Our Case Number: ABP-316272-23

Re: Bus Connects Templeogue/Rathfarnham to City Centre Core Bus Corridor Scheme
Templeogue/Rathfarnham to City Centre

BUSCONNECTS TEMPLEOGUE/RATHFARNHAM CORE BUS CORRIDOR SCHEME

Figure 1 Example of two stage pedestrian crossing at Camden Street/Charlotte Way

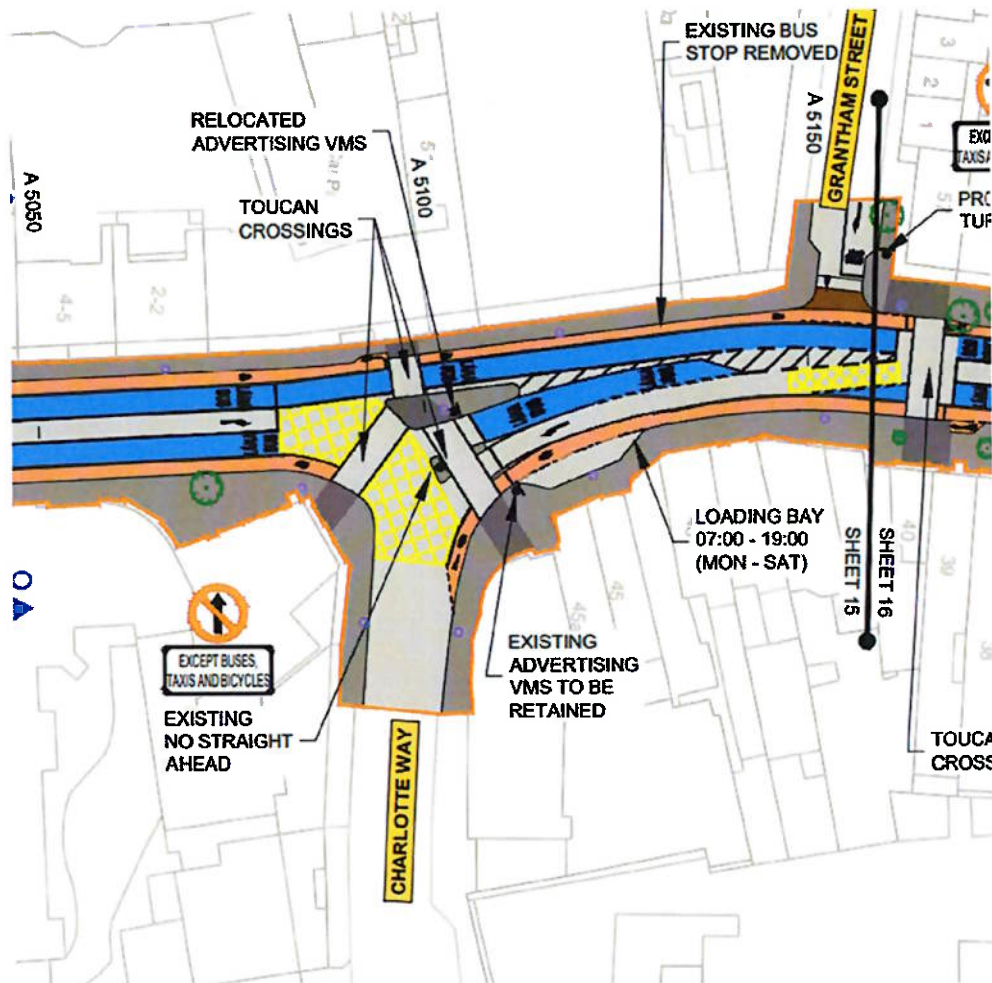
There are examples of two-stage pedestrian crossings proposed as part of this scheme. These crossings drastically increase the time required for pedestrians to navigate junctions and crossings. Section 4.4.3 Junction Design of the Design Manual for Urban Roads and Streets states that “designers should omit staggered crossings in favour of direct/single phase crossings” and Section 4.3.2 Pedestrian Crossings states that “designers should allow pedestrians to cross the street in a single, direct movement” and that “where staggered/staged crossings currently exist they should be removed as part of any major upgrade works”.

The following two-stage pedestrian crossings are clearly inconsistent with the Design Manual for Urban Roads and Streets:

- Camden Street Upper/Charlotte Way
- Highfield Road/Palmerstown Road
- Templeogue Road/Old Bridge Road

Pedestrian islands should be avoided where possible, it would seem far more prudent to adjust this junction, making a traditional T-junction. This would prioritise pedestrians

allowing them to make the crossing in a single journey, rather than being forced to wait at a pedestrian island no matter which way they go.

Figure 3 Bus stops with inadequate bus stop islands for cycling on Rathfarnham Road

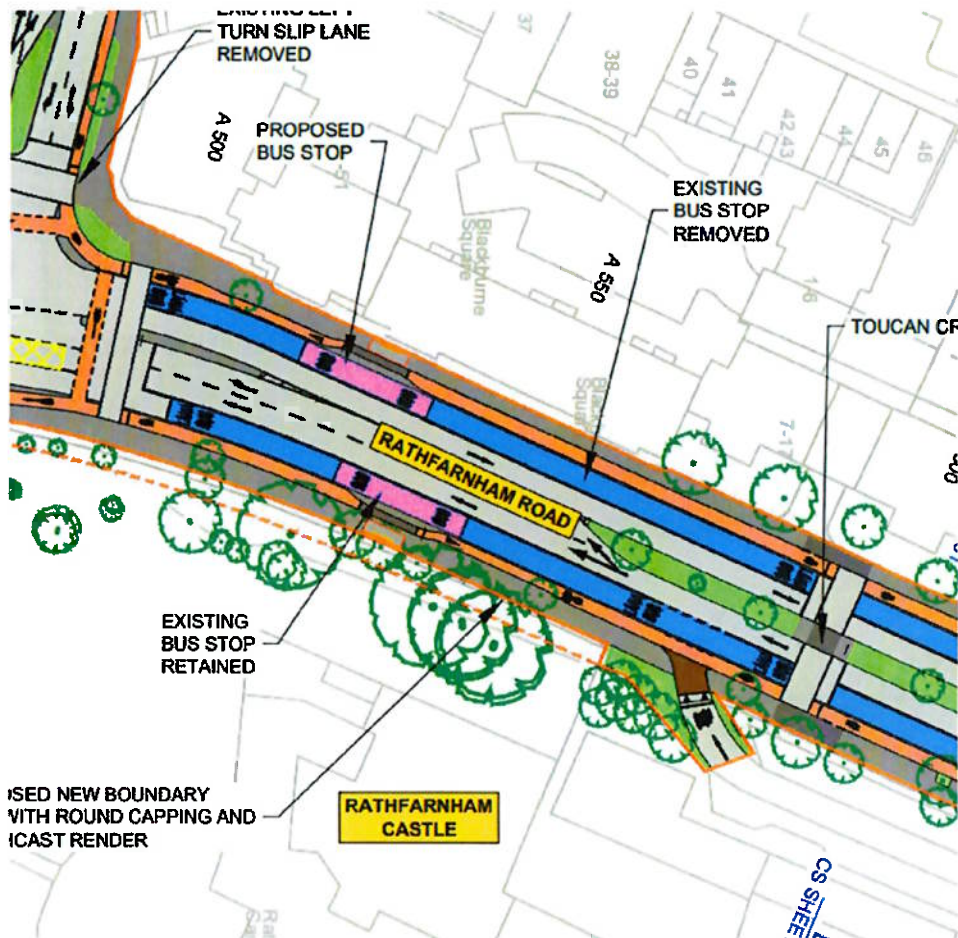
A major concern throughout the Proposed Scheme is the width of the bus stop islands that are proposed. Bus stop islands are crucial for the safety of cyclists and for encouraging all ages and abilities to use cycling infrastructure by removing conflicts between buses and bicycles. However, narrow islands place cyclists in conflict with boarding and alighting bus passengers.

Grange Road/Willbrook Road junction

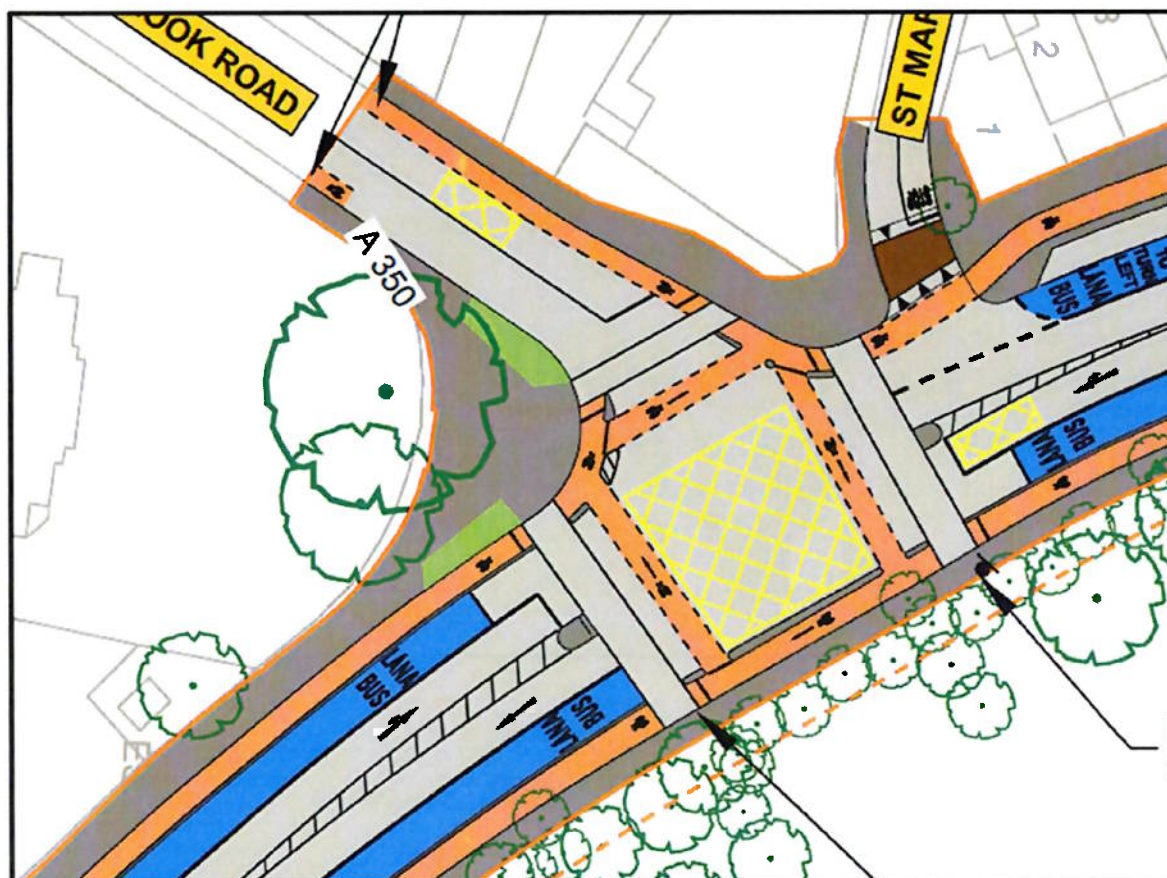
It appears that the bicycle lane on Willbrook Road is not complete from Grange Road and ends just after the junction, only to be reconnected slightly further down the road. There does not seem to be any physical reason in terms of road width at this junction for

forcing cyclists to interact with cars. This could lead to conflict between bicycle users and cars turning left onto Willbrook Road across the bus lane. We would suggest that the cycle lane continue past the junction on Willbrook Road, connecting with the existing infrastructure.

Rathfarnham Road/Main Street junction

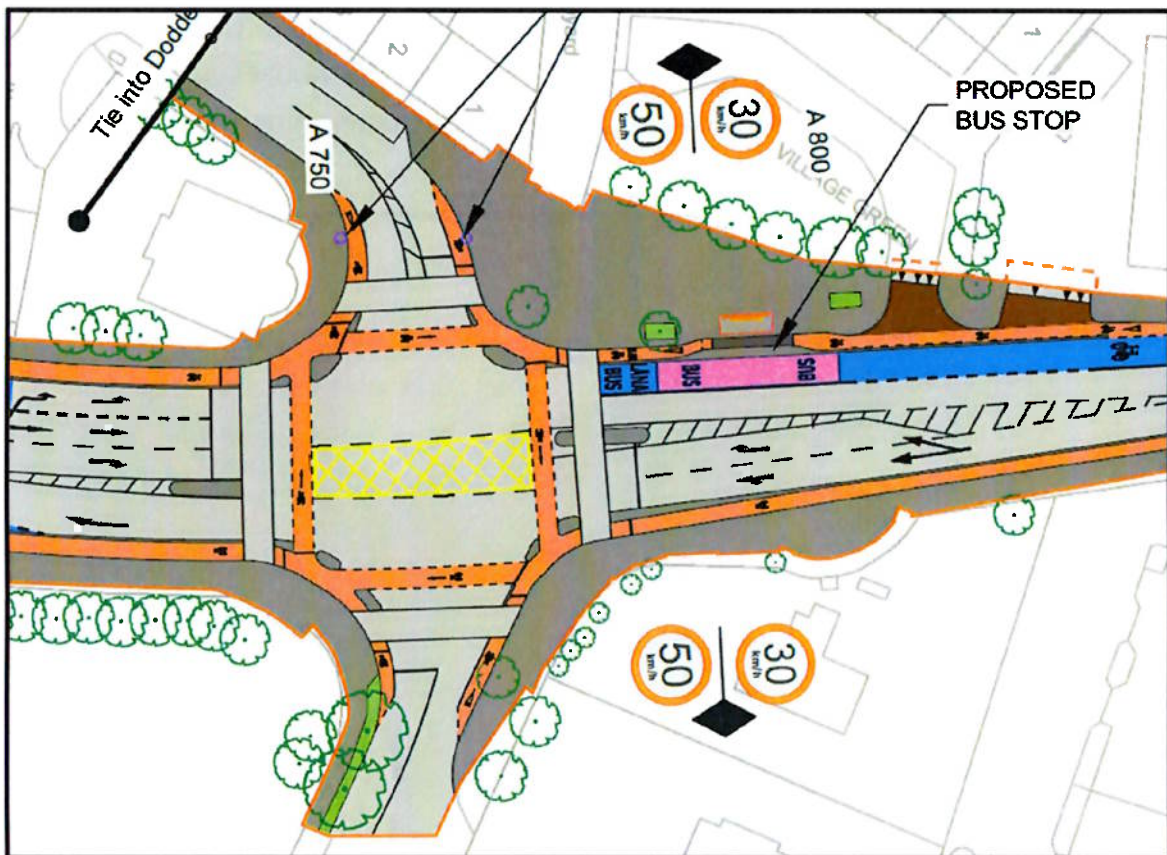
At the junction of Main Street and Rathfarnham Road (sheet 03/42), it is proposed that a bus stop be installed with a cycle track running in front of the shelter. As we previously mentioned, it is far safer to run the cycle track behind the bus shelter. As there is the available space to do so at this proposed stop, we would recommend that the bus shelter be brought forward and the cycle lane run behind to avoid potential conflicts between disembarking bus users and cyclists. The width of the island at this bus stop is also too narrow.

Rathfarnham Road/Dodder Park Road junction

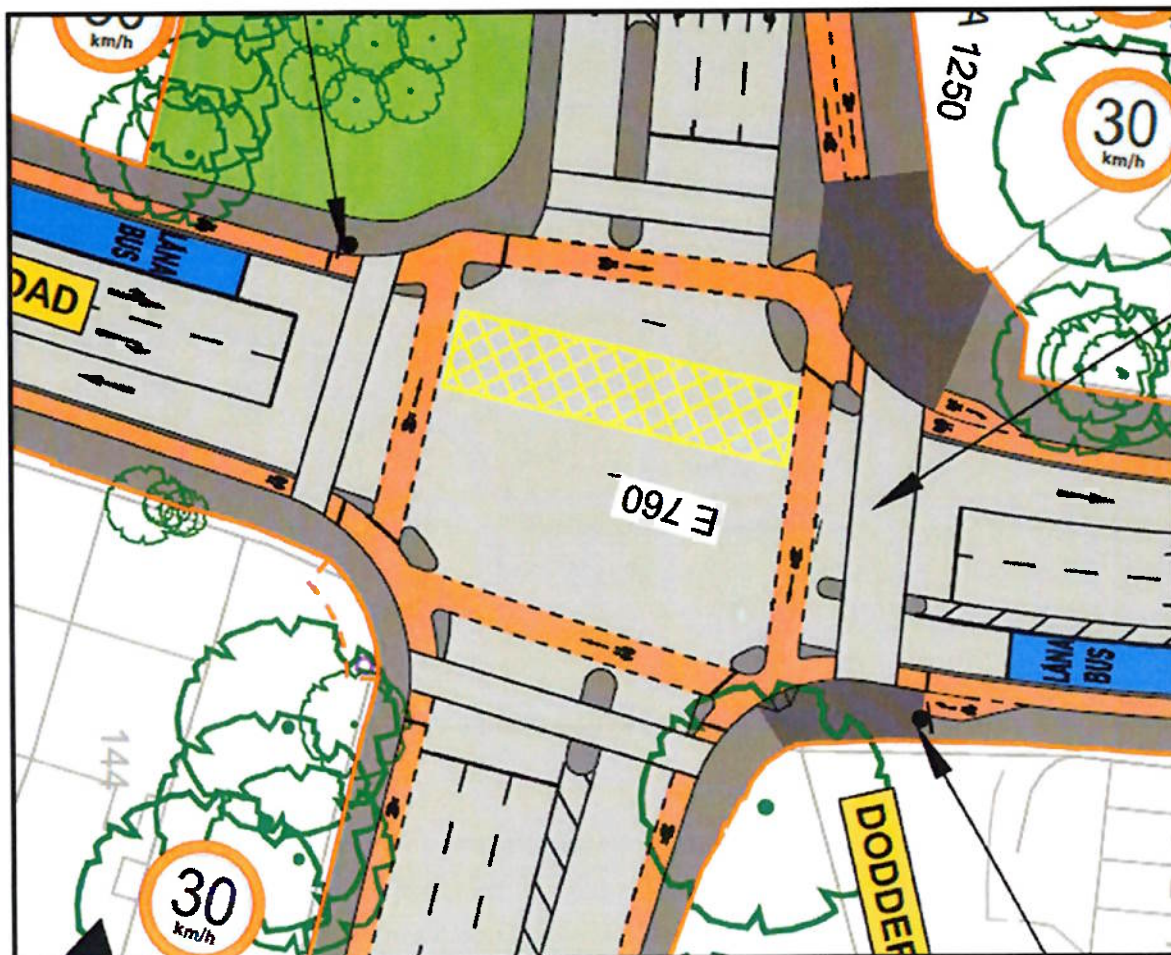
Given that there are three lanes of traffic on both sides of Dodder Park Road (sheet 04/23), we would request that priority signals be installed for cyclists at the junction. It is important to allow cyclists to fully clear the junction before left turning traffic arrives to make the turn. This could be mitigated by upgrading to a Dutch-style junction as mentioned above.

Additionally, there appears to be a shared space areas for pedestrians and cyclists. This would likely lead to conflict between faster moving cycle traffic should cyclists have the green light at the junction while creating a separation from cars who may have the filter lane turn left. We would recommend creating clear segregation between the cycle tracks

and pedestrian footpaths to reduce potential conflicts between both cyclists and pedestrians & cyclists and vehicles at the junction.

Rathdown Park/Rathfarnham Road junction

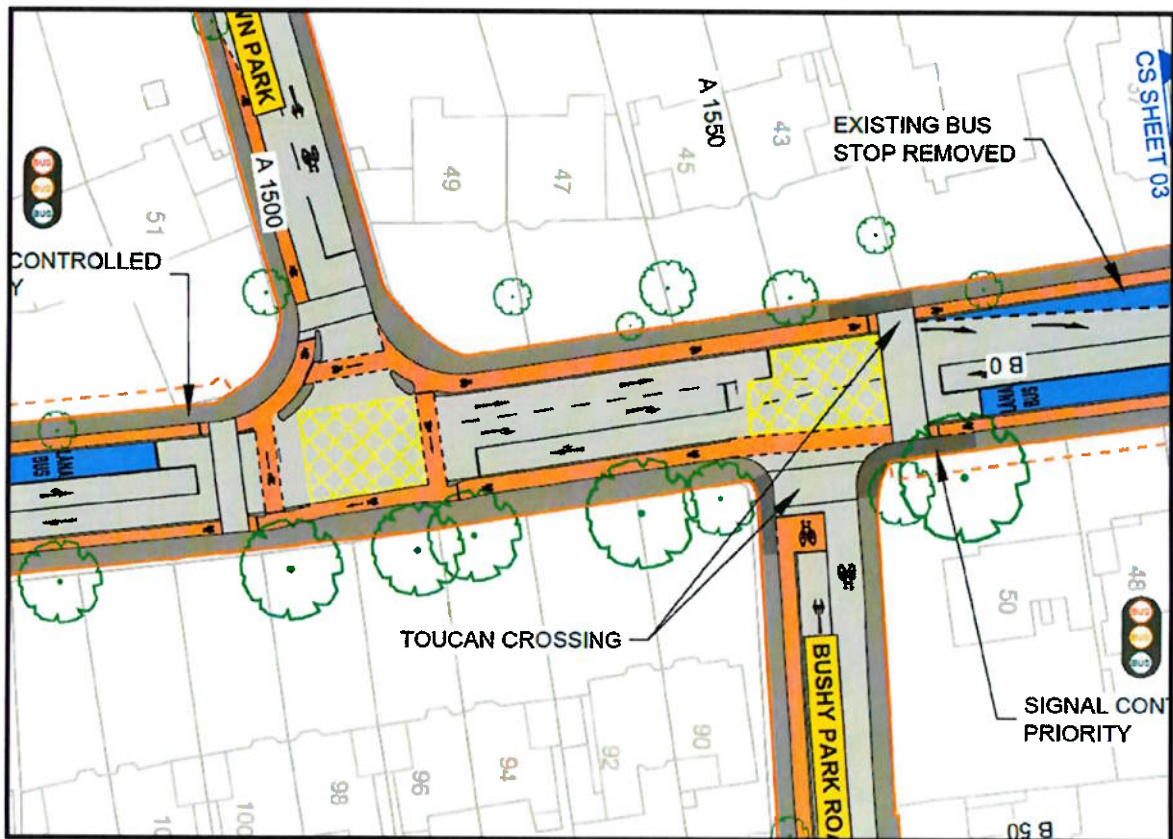
It appears that at the junction of Rathdown Park and Rathfarnham Road (Sheet 05/42), that there is no pedestrian crossing on the eastern arm of the junction despite there being a cycle crossing. This forces pedestrians to make an additional unnecessary crossing to get across the road and we would highly recommend installing a pedestrian crossing alongside the cycle crossing on the eastern arm.

This effectively forces pedestrians who may be coming from Bushy Park Road on the western side and want to get to the eastern side of Rathdown Park to make an additional crossing to get around the 'staggered' junction. It is not appropriate to prioritise vehicles over more vulnerable road users, especially considering Rathdown Park is supposedly a quiet street area, yet is designed to enable vehicles over pedestrians in the current design.

Cycle lanes on Terenure Place & Terenure Road East

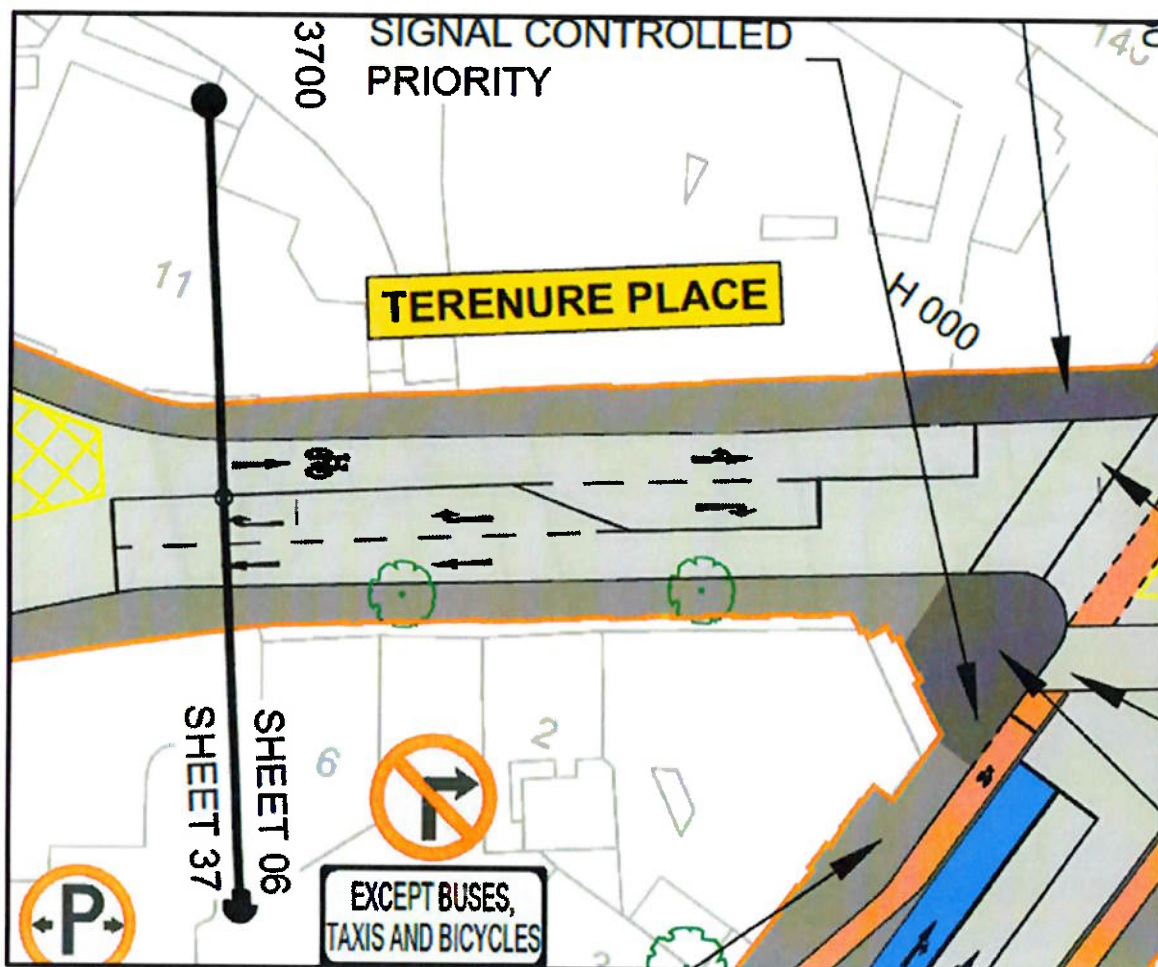
It appears that the current drawings do not include the existing cycle lanes on Terenure Place and at Terenure Road East. We would be against removing them if this is the proposal and not an oversight. Whilst painted lines on a shared road is the worst form of cycle lane, at the very least, it creates a clear demarcation between vehicles and cyclists.

We would ask the designers to re-visit these plans and ensure that the existing cycle lanes on Terenure place are not removed and update the drawing to reflect them.

Terenure Road East/Aldi Entrance

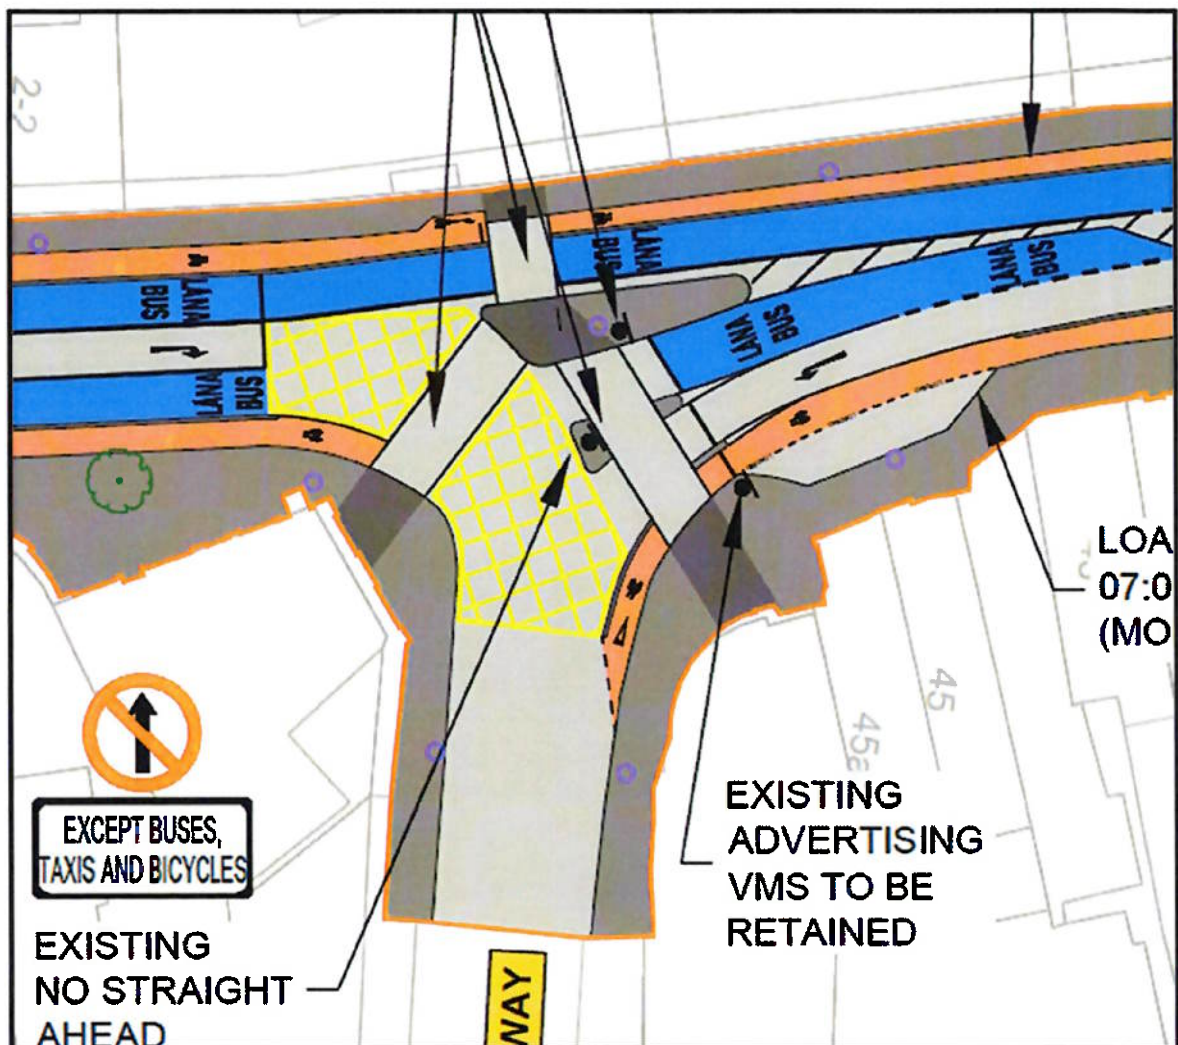
We request that the applicant implement a continuous footpath at the entrance to Aldi on Terenure Road East in order to prioritise pedestrians over vehicle users who may be entering / exiting the Aldi car park.

South Great George's Street Bus Stop

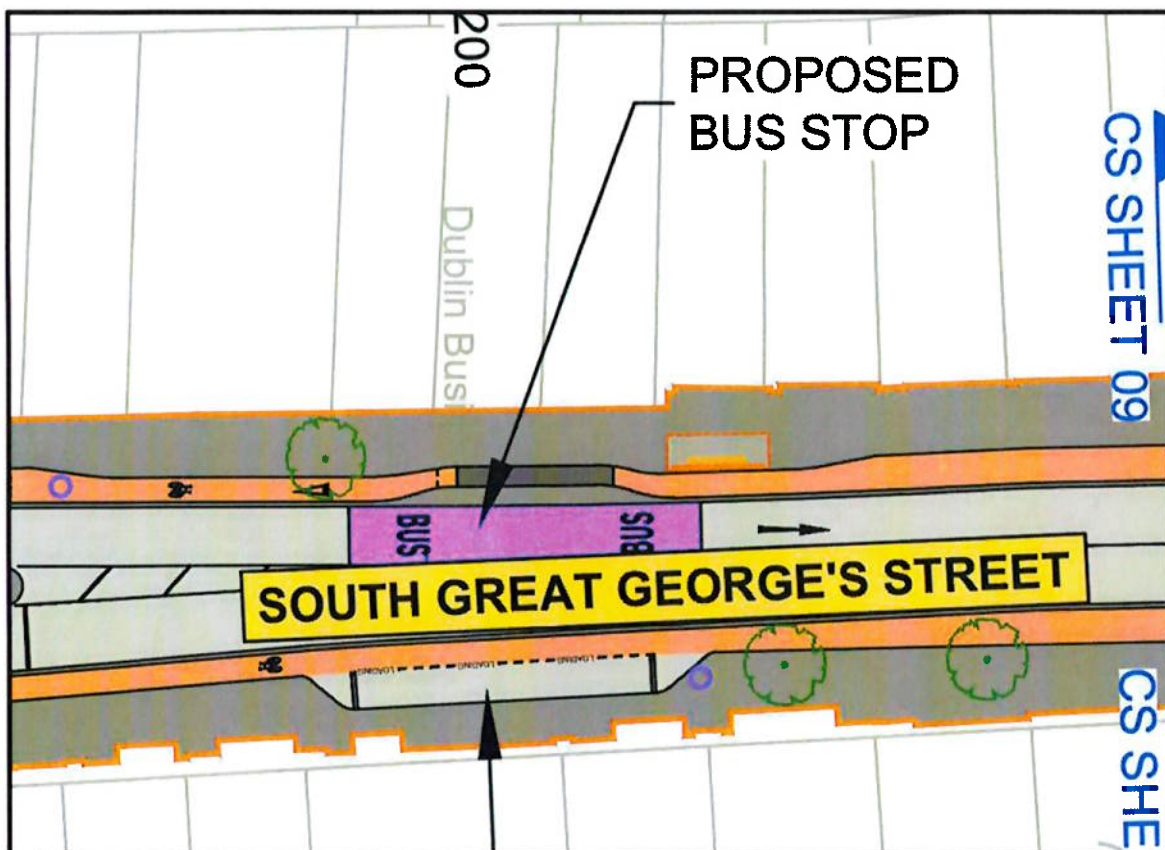
The placement of the bus shelter on South Great George's Street (sheet 18/42) does not align with the pedestrian island to disembark from the bus. There is a possibility that pedestrians might walk through the cycle track, rather than up and around the traffic island where cyclists are likely to be waiting, increasing the chances of a conflict. We would recommend making adjustments to the plans to align the bus stop with the traffic island to avoid this potential conflict point between cyclists and pedestrians.
